Memo: M013-B

Manchester Goods Yard

Acoustic testing schedule

This memo details the proposed Shell & Core acoustic commissioning testing for Manchester Good Yard.

1 Level 10 Roof
1 : 200

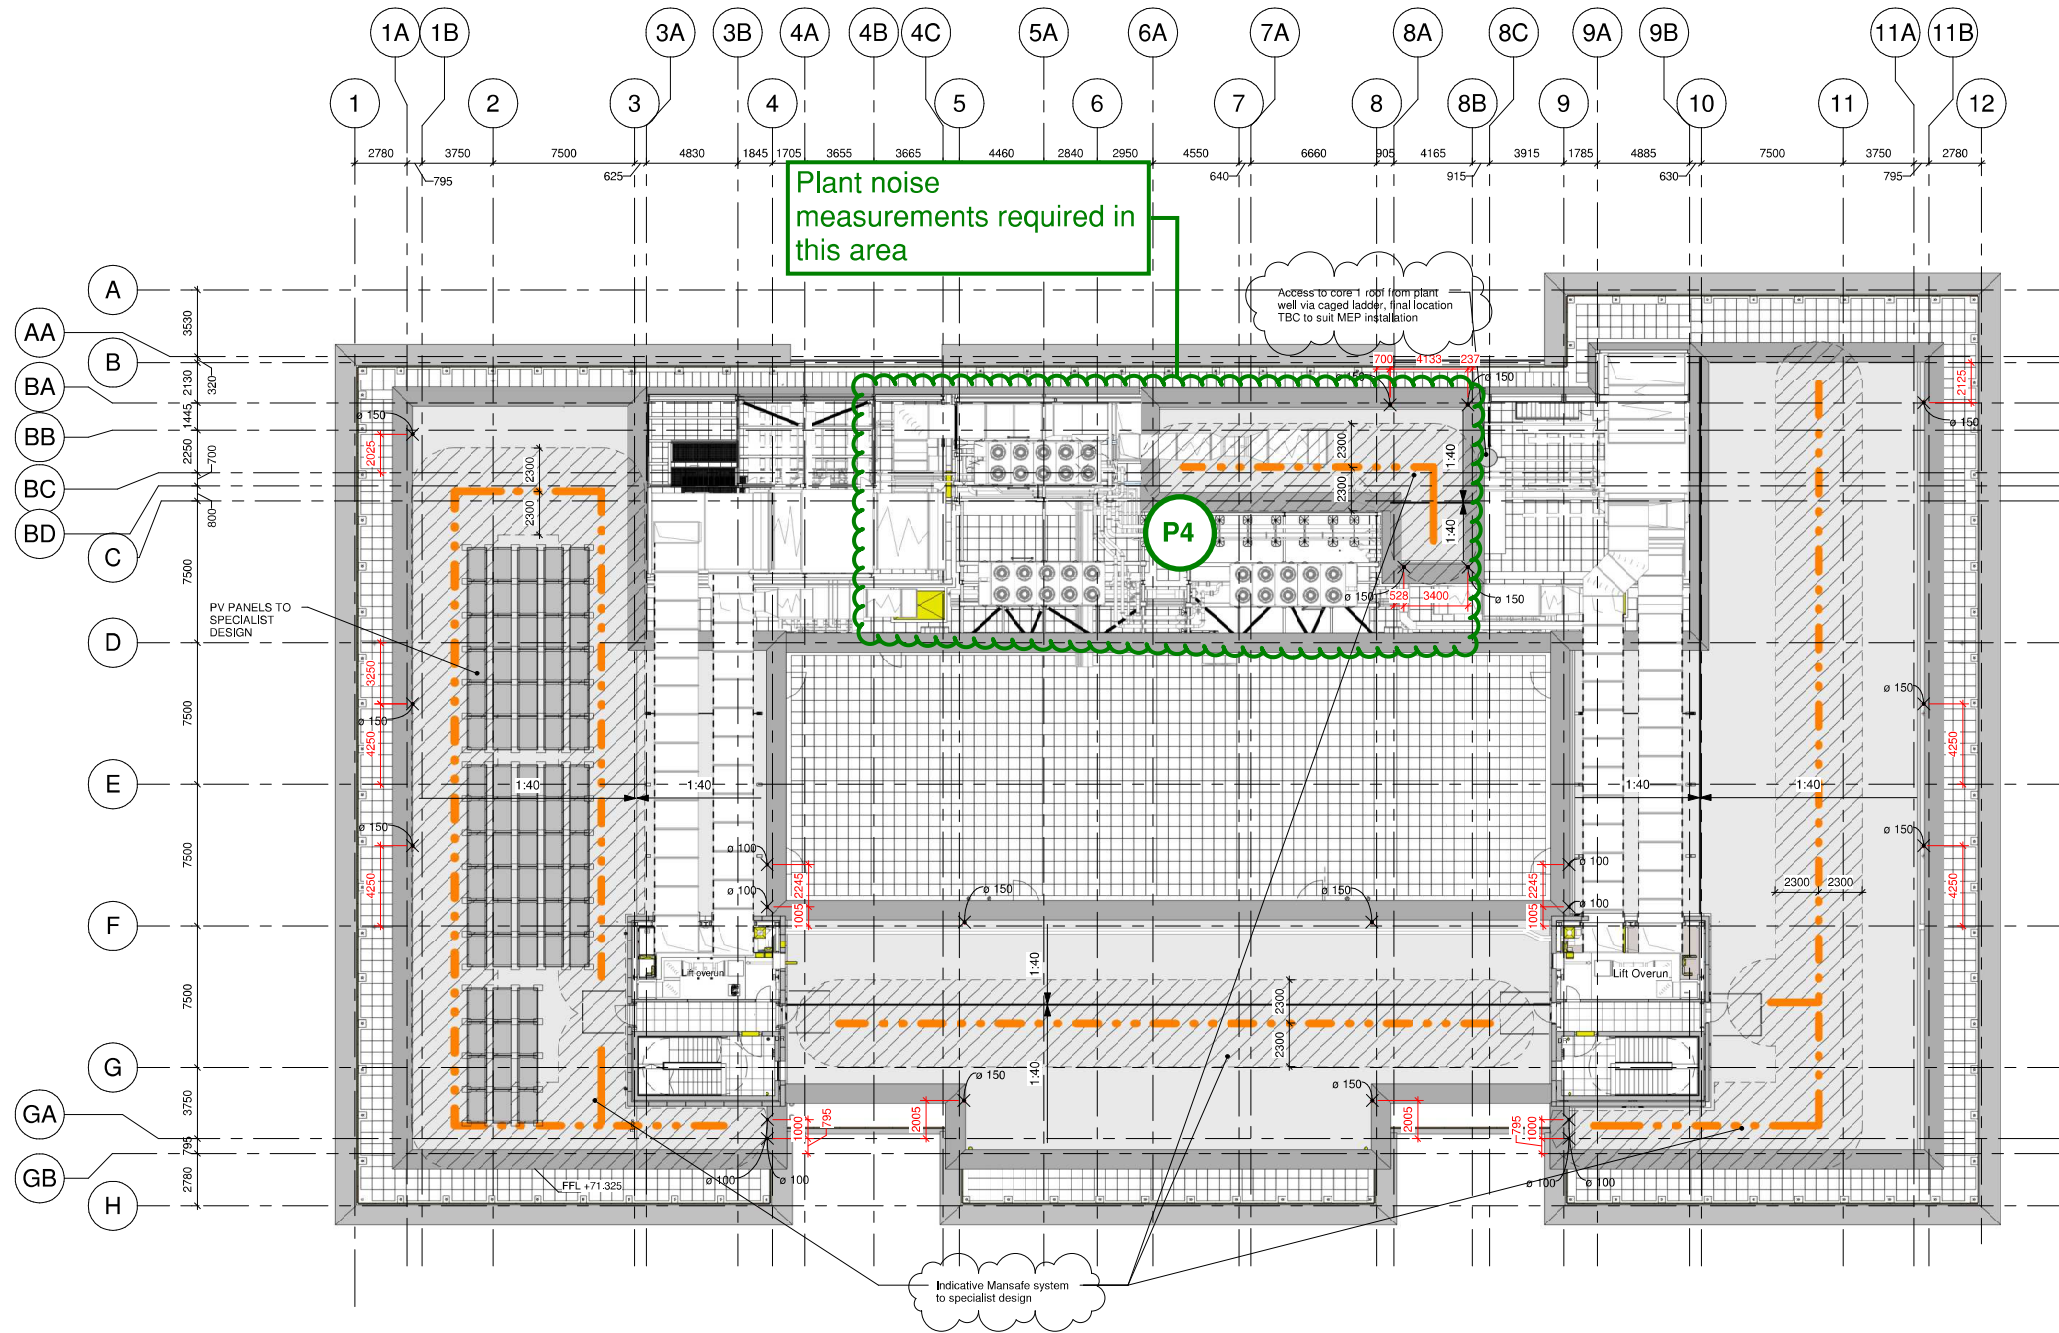
The proposed spaces in which measurements are proposed are indicated as P (in green), in the mark-ups at the end of the memo. The final measurement locations will be select on-site by the engineer carrying out the measurements.
